DRAINAGE LETTER
FOR
STERLING RANCH ROAD AND
BRIARGATE PARKWAY INTERIM PLAN

May 2023
Project No. 25188.03
PCD Filing No: CDR221

DRAINAGE LETTER FOR STERLING RANCH ROAD & BRIARGATE PARKWAY

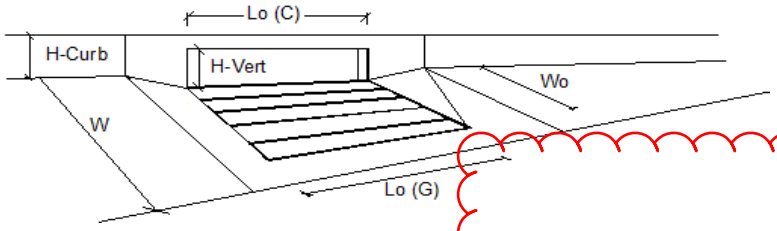
6.7 & 13.2...will increase by-pass and affect downstream.

STERLING RANCH ROAD & BRIARGATE PARKWAY STORM PLANS
PRIVATE POND FSD-11B (INTERIM DESIGN)
POND PLAN

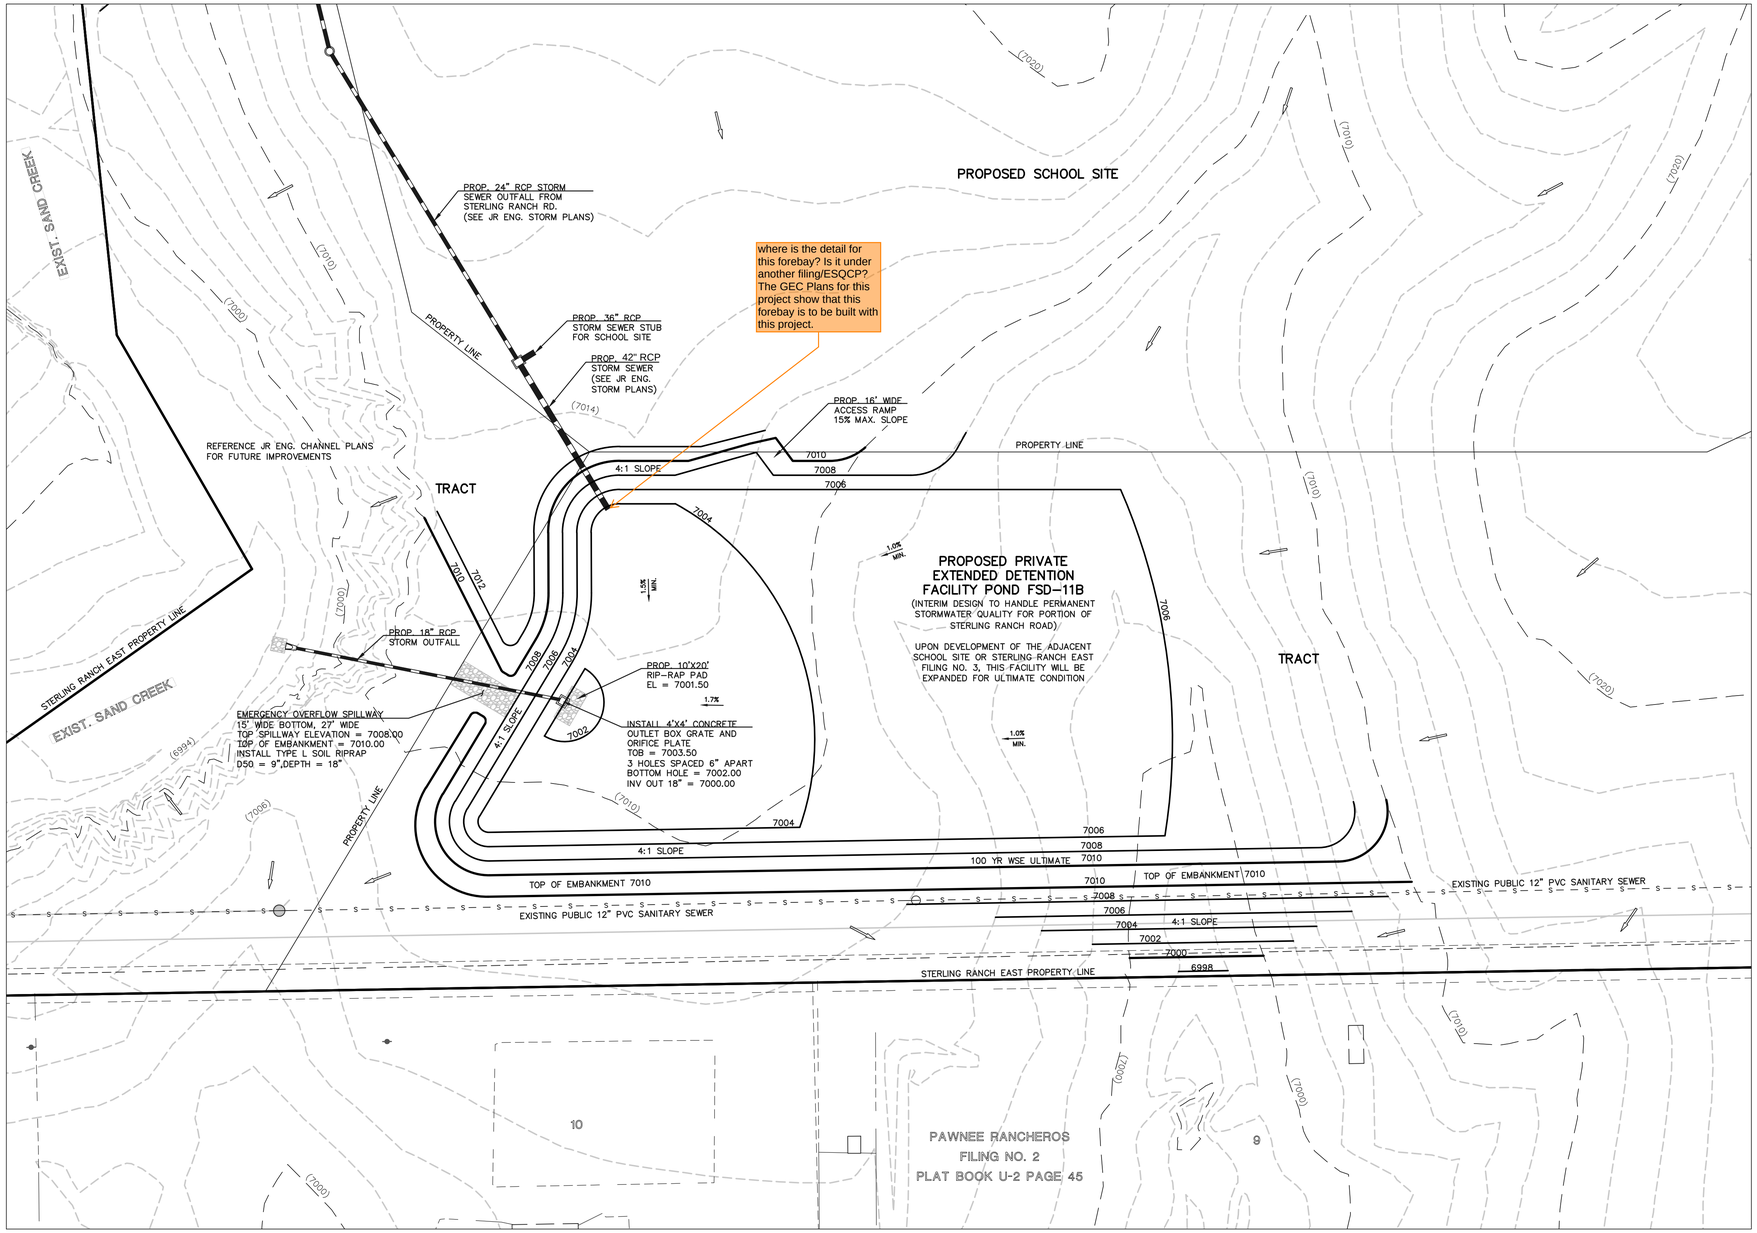
where is the detail for this forebay? Is it under another filing/ESQCP? The GEC Plans for this project show that this forebay is to be built with this project.

Added/Addressed, see Appendix D.
